In the Matter of
Southern Nuclear Operating Company
License Amendment Application for
Combined Licenses NPF-91 and NPF-92
Vogtle Electric Generating Plant Units 3 and 4
Docket Nos. 052-00025 and 052-00026;
NRC-2008-0252-0057

DECLARATION OF ARNOLD GUNDERSEN TO SUPPORT THE
PETITION FOR LEAVE TO INTERVENE AND REQUEST FOR HEARING
BY THE BLUE RIDGE ENVIRONMENTAL DEFENSE LEAGUE REGARDING
SOUTHERN NUCLEAR OPERATING COMPANY'S
VOGTLE ELECTRIC GENERATING PLANT UNITS 3 AND 4
REQUEST FOR LICENSE AMENDMENT AND EXEMPTION:
CONTAINMENT HYDROGEN IGNITER CHANGES (LAR-15-003)

Thermal Image of Radiation Leaking From Fukushima Daiichi Unit 3 Containment

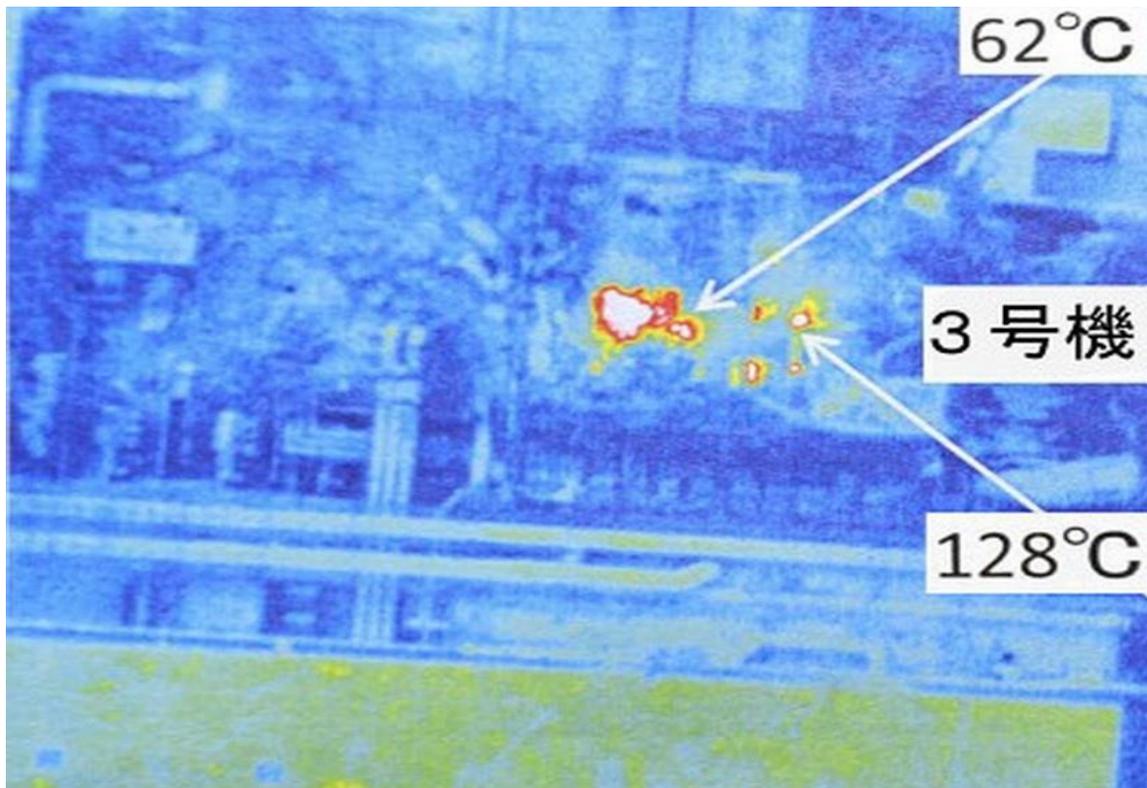
- 34.3. Below is a infrared photograph of Fukushima Daiichi Unit 3 taken by TEPCO several weeks after Unit 3 was destroyed by a detonation shockwave.
 - 34.4. The reader is directed to the 128C gases being vented at the center of the photo. This cannot be steam, as it exceeds 100C and must therefore be hot radioactive gases being released directly from the top of the containment.

34.5. The AP1000 containment could react in a similar fashion if the proposed hydrogen igniters are installed.
